E4440A-20

**S E R V I C E N O T E**

E4440A - PSA Series Spectrum Analyzer

**Internal Alignment Failures for PSA Series Spectrum Analyzers Manufactured Between January 2004 and February 2006 Caused by Low Power Output from A9A1 DRO on A9 Second LO Assembly**

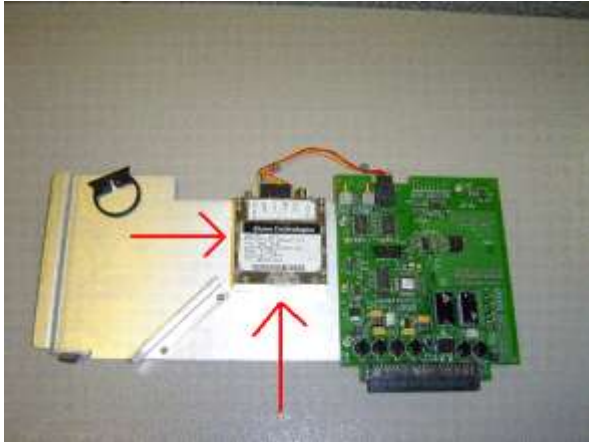
Verify the alignment failure by looking at the error queue for the error message “-340, Calibration failed, Align\_2<sup>ND</sup>\_LO\_PWR”. Press [System] <Show Errors> <Next Page>. Typically, when the Second LO power is too low, it will be the first failure listed in the alignment queue, which will be at the bottom the Second page of alignment errors (as shown below):

Replace just the DRO by removing it from the Second LO assembly and replacing it with a new one.
